**BZA-2073**  
**JON SHEIDLER – LANDWORX ENGINEERING**  
**(variances)**

**STAFF REPORT**  
**March 17, 2022**

**ARBY'S RESTAURANT**  
**EAST 600 NORTH AND NORTH RIVER ROAD (SR 43)**  
**BATTLE GROUND, INDIANA**  
**SITE PLAN**

**C200**

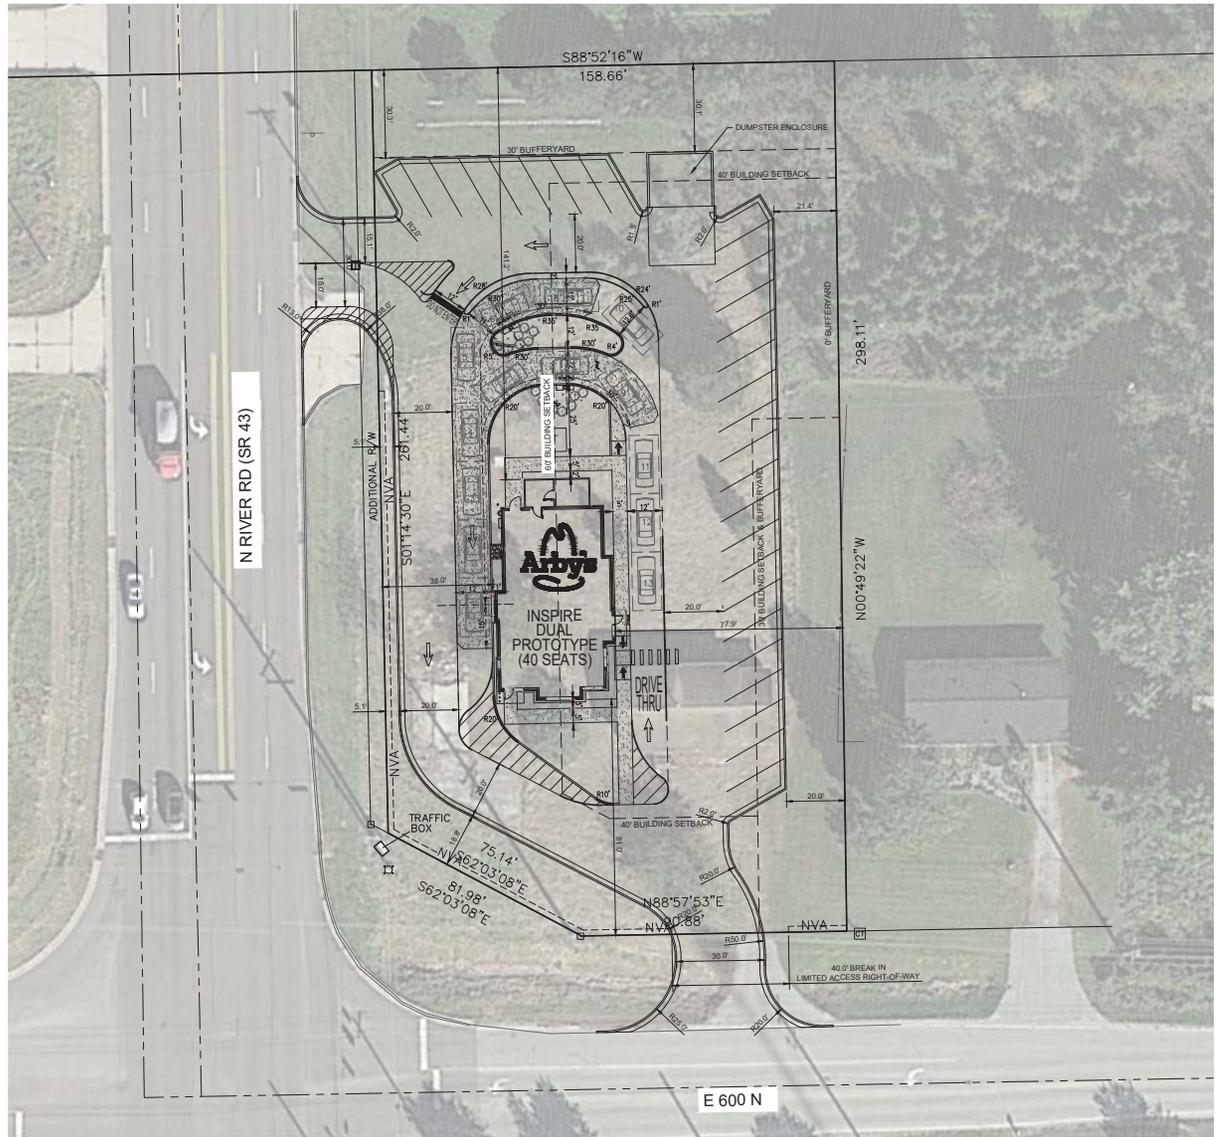
The site plan shows new access points from both SR 43, slightly north of the current driveway, and 600 N, slightly west of that current driveway.

The petitioner is meeting their required amount of parking, with 28 spots shown, when 27 are required for their gross floor area in an HB zone.

The petitioner is requesting two variances. The first would allow a building setback of 38' instead of the required 60' from SR 43 on the western lot line. The second would allow a 20' bufferyard instead of the required 30' along the eastern lot line, where the property abuts an R2 zone. The lot dimensions are 298.11' by 158.66'. If the petitioner were to meet the required setback and bufferyard requirements, they would be left with 68' for the building, driving and drive-thru lanes and parking. Alternately, switching the site of the building and side parking to be closer to the R2 zone on the east would allow the building to meet the required setback of 60' along SR 43. The bufferyard however would still be narrower than 30', and the required parking spots would not be met, because the western property line is shorter than the one on the east (because of the angled southwest corner intersection).

Staff members feel an ethical responsibility to help preserve the pet cemetery for the community, which is still visited by family members today. As a condition of approval for the two variances in this request, a public access easement should be created for the cemetery, with a gated fence separating the parking lot from the bufferyard zone. Staff also recommends that the bufferyard plantings be placed such that no headstones are disturbed.

1. Prior to building permit issuance, record a public access easement to the existing pet cemetery with a gated fence between the parking lot and greenspace.
